July 6, 2026

ADDENDUM 1

ARQ AVIATION

FLIGHT SCHOOL + FBO

A-103

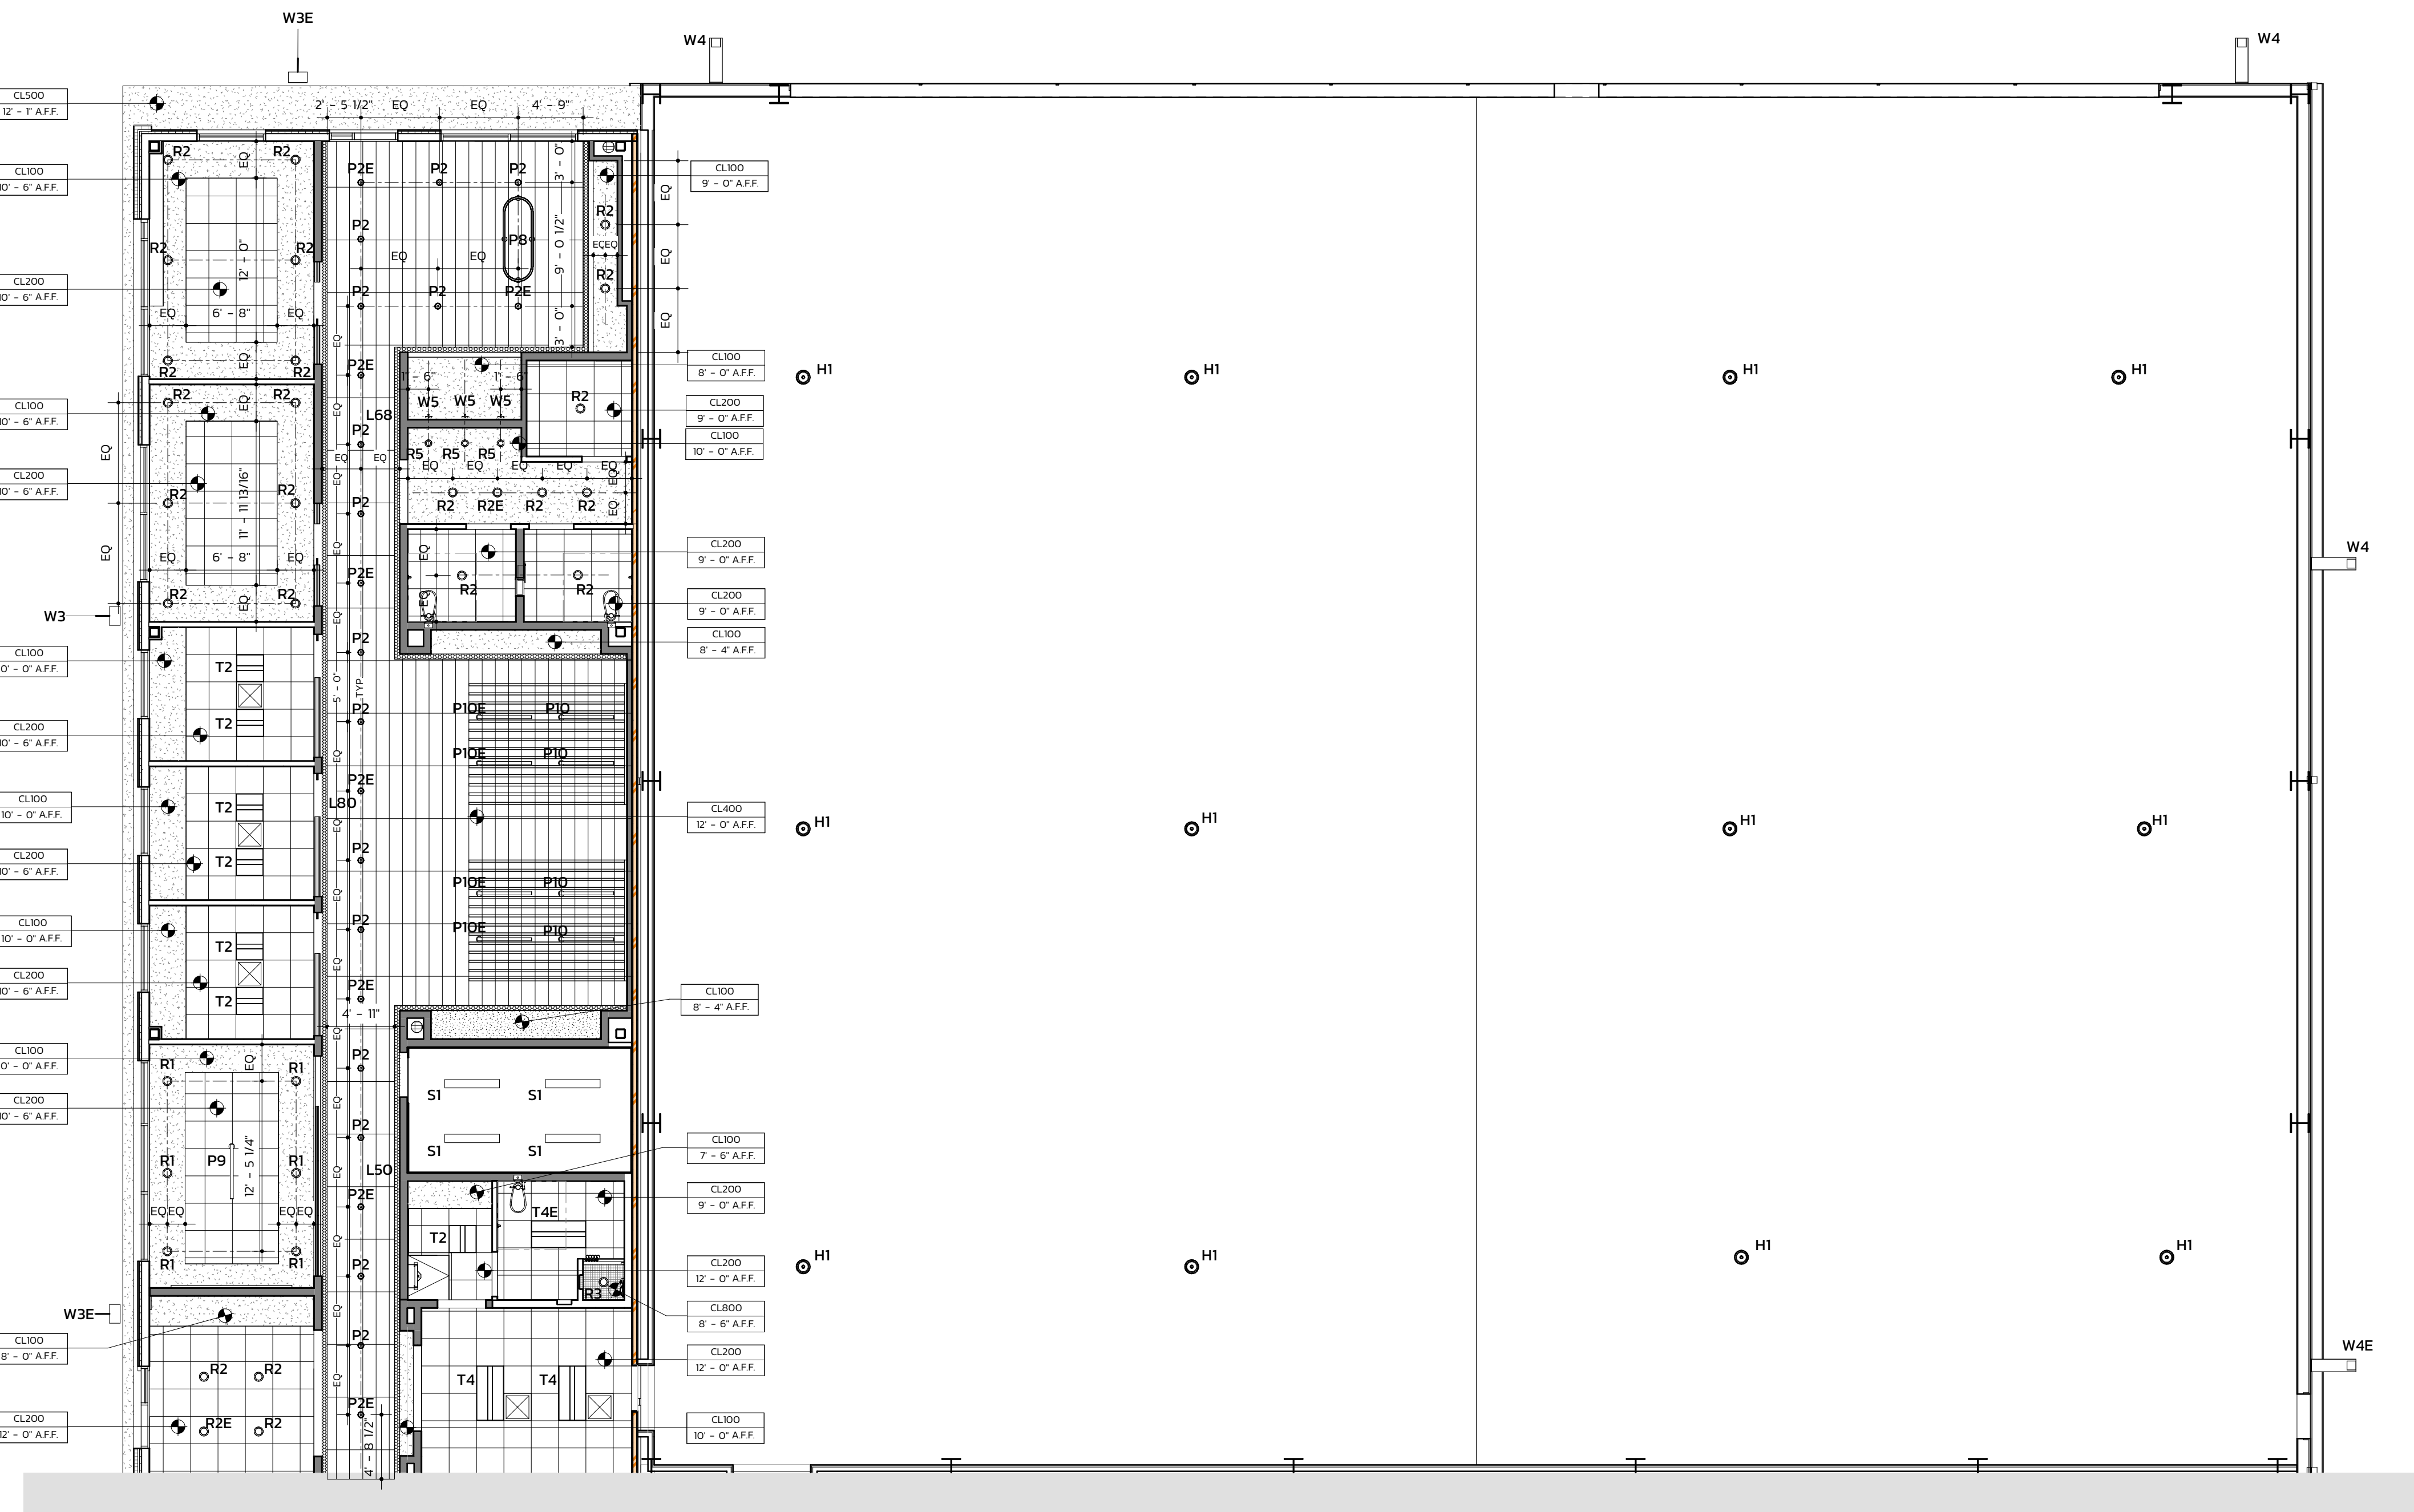
1. The Reflected Ceiling Plans on sheets A-103, A-103A and A-103B do not line up with the information provided on the Finish Schedule on page A-701. The RCP refers to CL200, CL300, CL400, and CL600, but none of these materials are referenced in the Finish Schedule. The legend mentions ACT-1, ACT-2, and ACT-3, but the descriptions do not match what seems to be the intent per the RCP. **See updated ceiling material legend that refers back to finish schedule. Finish schedule also updated with materials**

2. It is unclear which item corresponds to which material. BAF1 and BAF2 are mentioned in the Finish Schedule, but the materials do not match what the Ceiling Material Legend shows on the RCP. **TD updated schedule + ceiling material legend for clarity**
3. There seem to be baffles under CL400 per the RCP, but these are not labeled. Please clarify which materials go here. **These are BAF6 (1/A-416). Need to coordinate how the baffle tracks work with the suspended ceiling. These baffles are the same ones we used in the TD office**
4. The RCP refers to “Acoustic Tekton Panels” in Training 103, but it seems the materials for this application are not described. **TD updated schedule + ceiling material legend for clarity**
